CERTIFICATE OF APPROPRIATENESS

Property: 805 Franklin Street, Lots 3, 4, & 5, Block 16, SSBB Subdivision. The property is a vacant lot situated on a 15,002 square foot (150’ x 100’) corner lot.

Proposal: New Construction – *This project was deferred at the July 2016 HAHC meeting so that the applicant could further work with staff.*

Recommendation: Deferral – The applicant has requested a second deferral of this project.

3D RENDERING – FRONT FACING FRANKLIN STREET

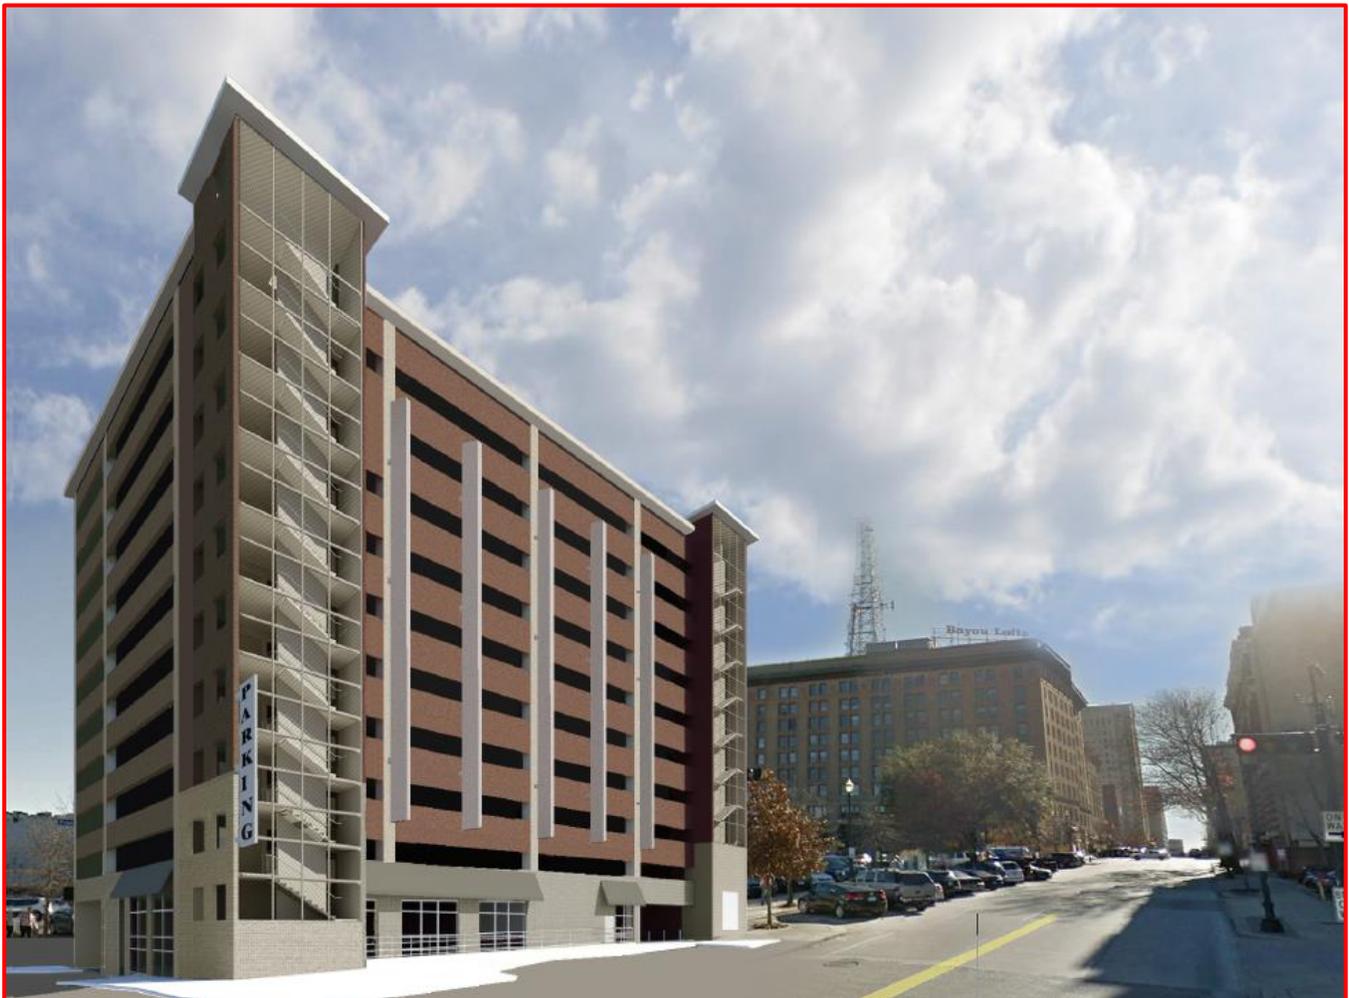
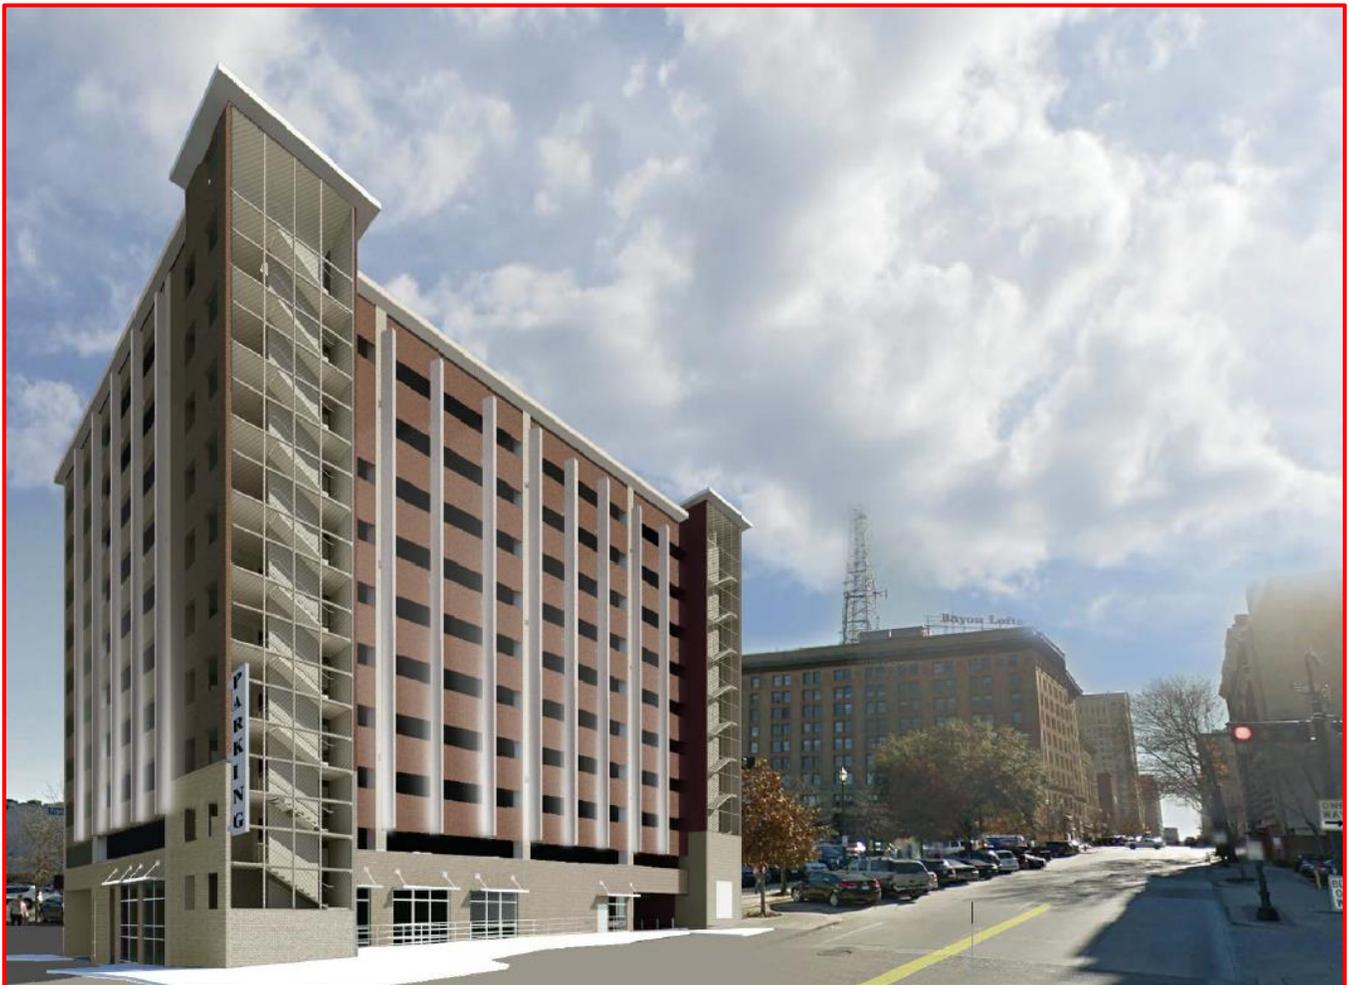
The applicant and staff have diligently worked together in order to design a compatible structure that compliments the existing historic buildings in the district. However, at this point, the exterior features of the proposed structure are not fully compatible with the exterior features of other contributing structures in the context area.

The applicant has based the current design on existing noncontributing parking garage structures within the district, despite insistence from staff that these structures are noncontributing and are not taken into account to determine compatibility with the district.

Although being relatively tall, the massing, scale, and proportion of the structure appears to fit within the district, as there are taller buildings are present within the district along with the typical two – three-story structures. The main issues of the project involve the horizontal nature of the structure as well as the street level detailing. Satisfying criteria can be accomplished by incorporating more vertical elements to better match vertical elements, such as window openings, that are typically found within the district. Although this can be partially seen on the Milam elevation with the inclusion of vertical aluminum window frames; the square frames and overall horizontal nature along the Franklin side is uncharacteristic of the district. At the ground level, suspended awnings as opposed to cloth awnings should be installed above the storefronts. This type of awning is more typically seen throughout the district, and is more historically appropriate. The use of additional brick veneer and perhaps some form of curtain wall may also make the structure more compatible with the Main Street Market Square Historic District.

Staff would also be in support of a more contemporary design that is able to incorporate the massing and components of other historic buildings within the district. Historically, the taller structures within the district feature a distinct base, a rhythmic series of vertically oriented bays, and a prominent cornice. The system of base, bays, and cornice should be replicated in the proposed design. On the ground level, the incorporation of a false store front system (complete with delineated with knee walls and transoms) and topped by deep overhanging suspended awnings will help identify the pedestrian focused nature along the street level. The use of vertical screens and panels installed at spaced intervals along the two street facing elevations will emulate the historic rhythm of bays while still maintaining the openness required of a garage. The structure should then be capped with a cornice to complete the traditional three part design of historic building. The overall design does not have to be ornate or over decorative, and in fact, should be simple and more refined. By featuring the components (extracted features) of traditional buildings, the structure will blend in and act as a benign backdrop to the surrounding buildings.

SOUTH ELEVATION –FACING FRANKLIN STREET

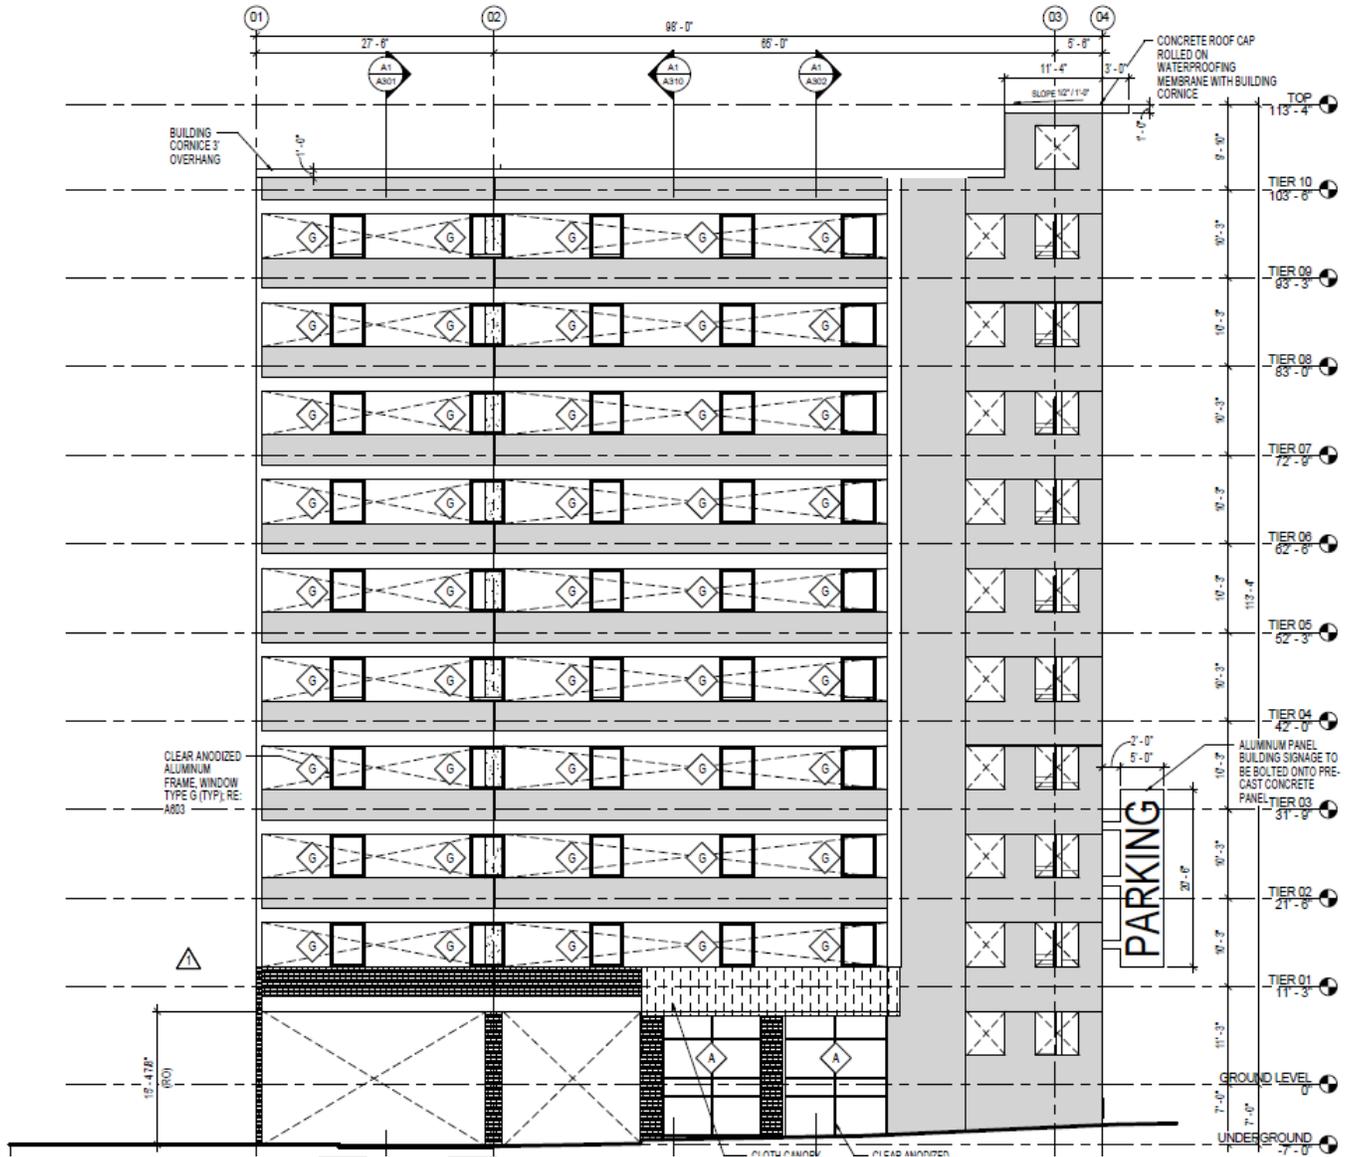
- The western edge of the west elevation should be more substantial and not so thin (A201)
- Perhaps the awnings be suspended awnings and extend the width of the building without being broken up

CHAIN LINK DETAIL

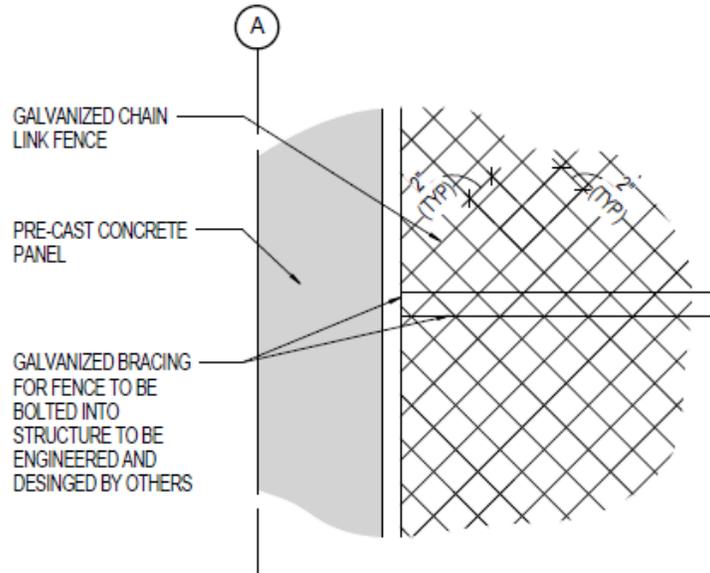
- e. Chain link – yes we need a small image of that with size – can this be added in plans? – I provided the detail A1/A202 can you take a look and let me know if you are ok with the verbiage?
